ADDENDUM #1

October 24, 2025

Project: **Virginia Polytechnic Institute & State University
Durham Hall Room 171/181 Phase 2 Mechanical/Electrical Renovations
IFB# 306852607
Blacksburg, Virginia 24061**

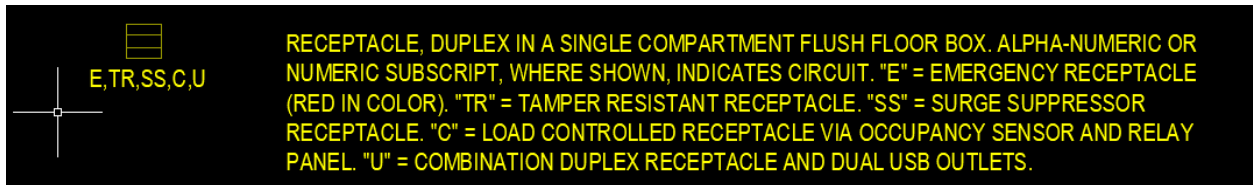
Question 2. Note 13 also refers to a floor box in lab 181. Is this box cast or can it be PVC?

LPA Response: the below snip is from E-000, LPA – PVC weather proof (adder for the WP). However would recommend asking the same question to the end users. Not sure about any chemicals.
